# Max Tap Regulators Implications

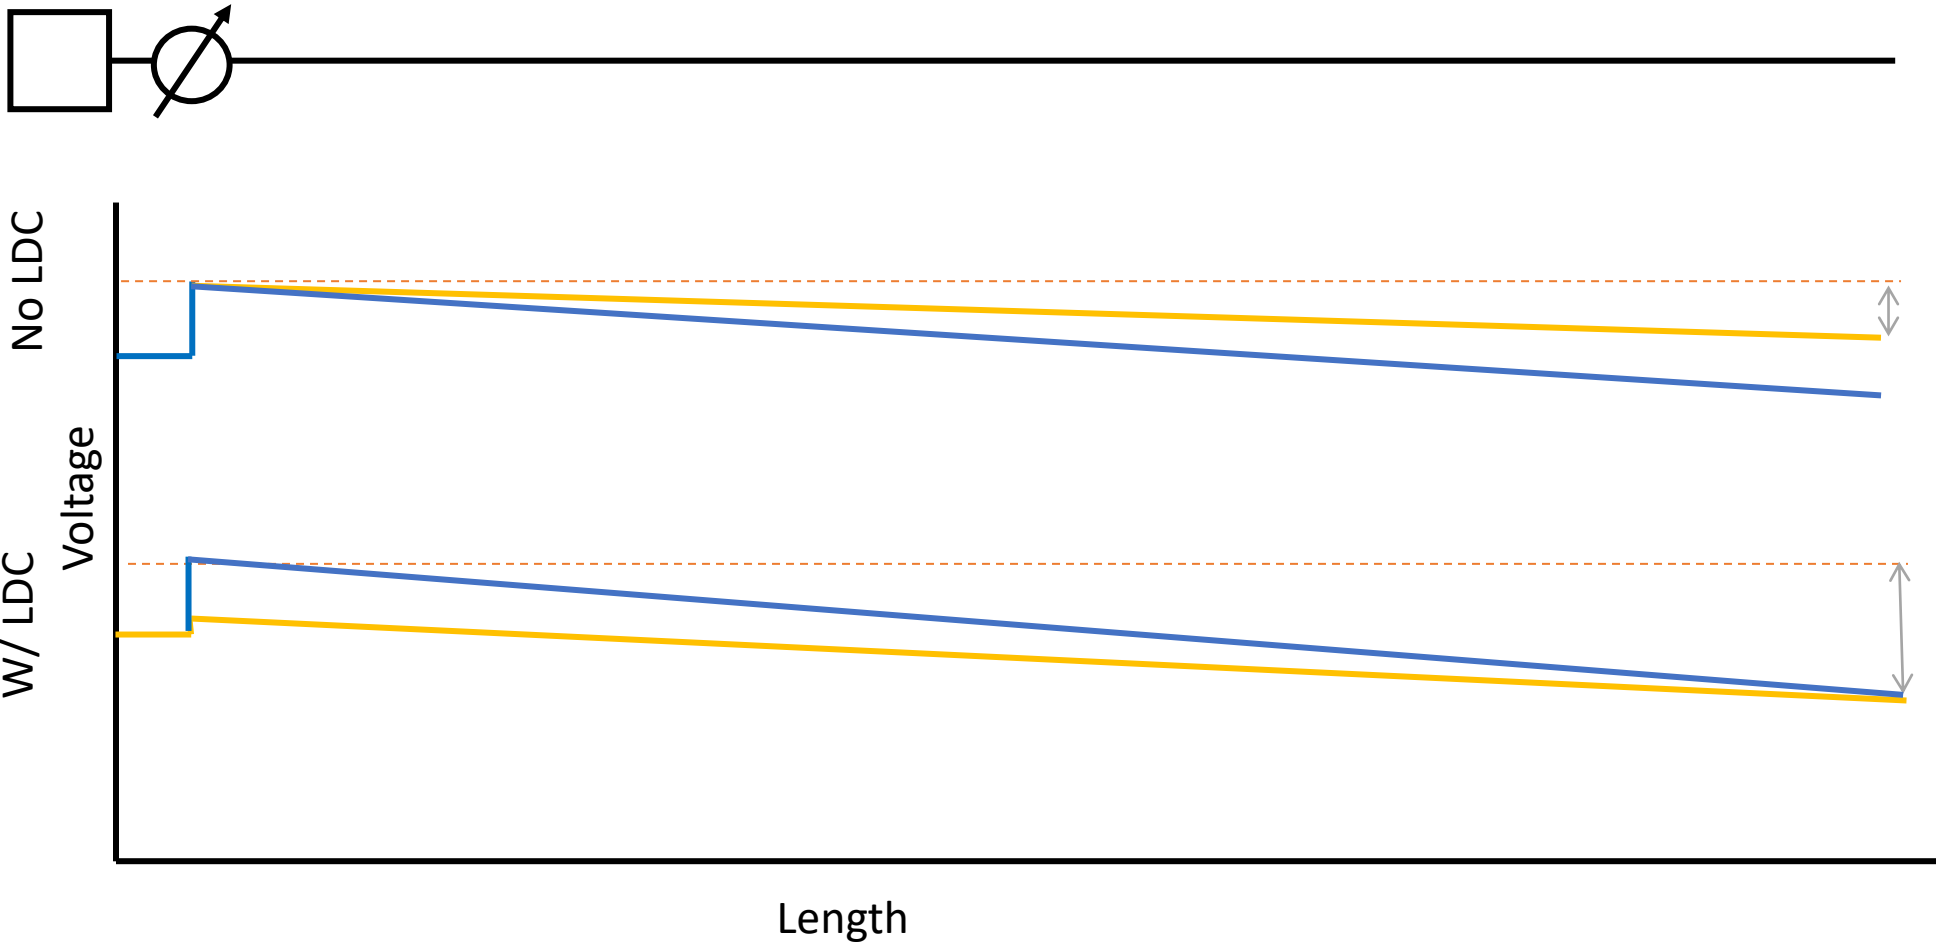
- Does the 'max tap regulators' setting increase voltage profile, in worst case by 1.5%, from baseline power flow (reducing voltage headroom by 1.2%)?
